**Case #:** ZBA 2012-19

**PLANNING STAFF REPORT**

**Site:** 240 Summer Street

Legal Notice: Applicant Frank Fazzolari and Owners Salvatore and Lina Fazzolari, seek a Special Permit to alter a nonconforming structure under SZO §4.4.1 to erect an approximately 3.5 foot high railing on the left side of the second story of an existing single-family residence. RB zone. Ward 5.

Existing Conditions

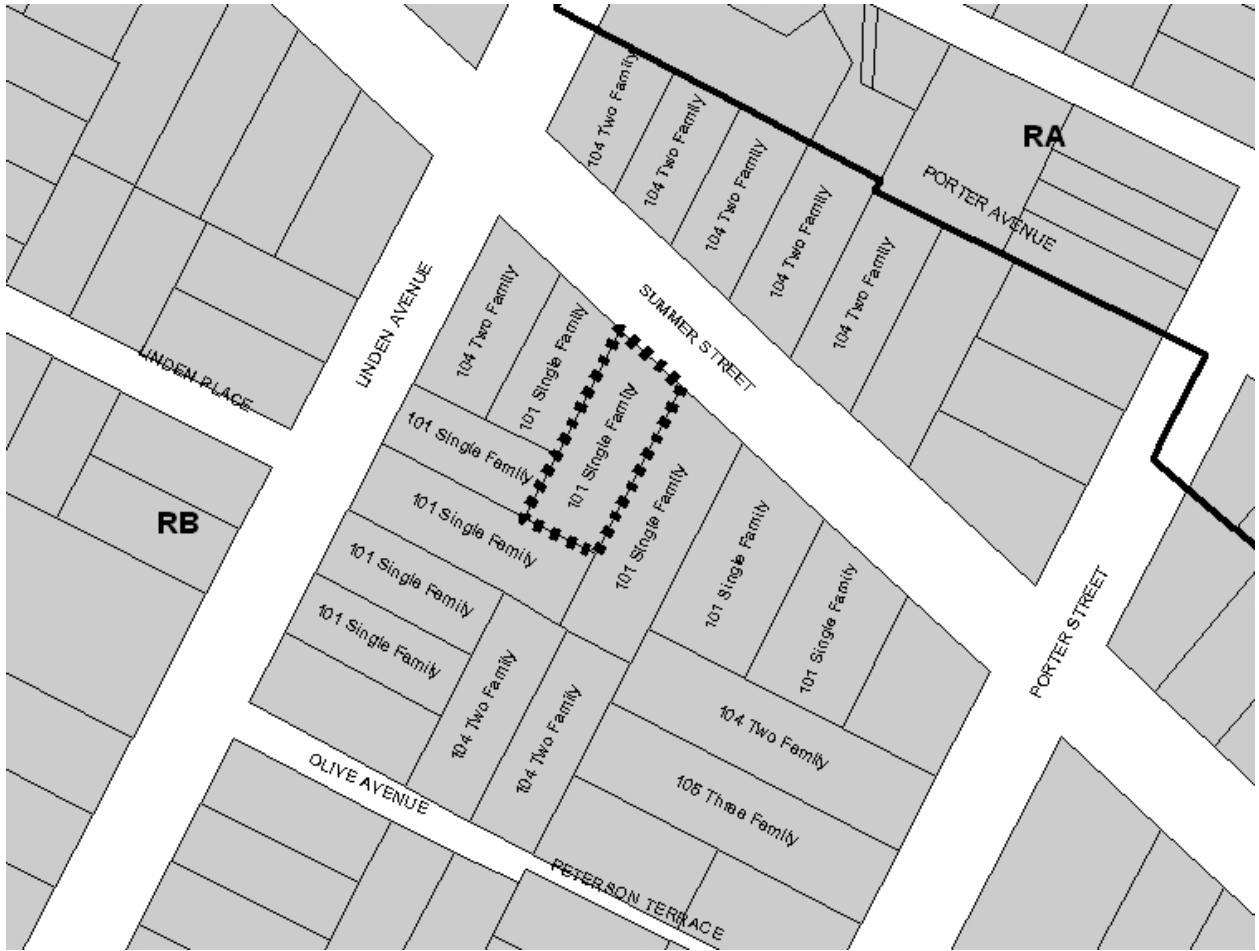
In considering a Special Permit under §4.4 of the SZO, Staff finds that the alterations proposed would not be substantially more detrimental to the neighborhood than the existing structure. As can be seen in the photograph above, the railing is only slightly visible from the public right-of-way, but does not impact any views from the neighbors or of the surrounding area. Since the Applicant is indicating that the small, 48 square foot fenced in roof area will only be accessed for snow removal purposes, noise and privacy concerns should not become issues with the abutters. To prevent any privacy or noise issues with the surrounding neighbors from ever arising, Planning Staff is recommending a condition that prohibits the occupants of the dwelling from using this fenced in roof area as a private outdoor space. The property will remain a two story, single-family residential use which is consistent with the surrounding neighborhood.

The project is compatible with the characteristics of the surrounding neighborhood. The railing is only slightly visible from the public right-of-way, but does not impact any views from the neighbors or of the surrounding area as it is located at the rear of the structure and within the existing footprint of the building. The railing will provide the property owners access to this small portion of flat roof to prevent any heavy snow accumulation from occurring there and potentially damaging the structure. The design and size of the railing is not out of context with the architecture of the subject building or with the surrounding neighborhood. The property will remain a two story, single-family residential use which is consistent with the surrounding neighborhood.
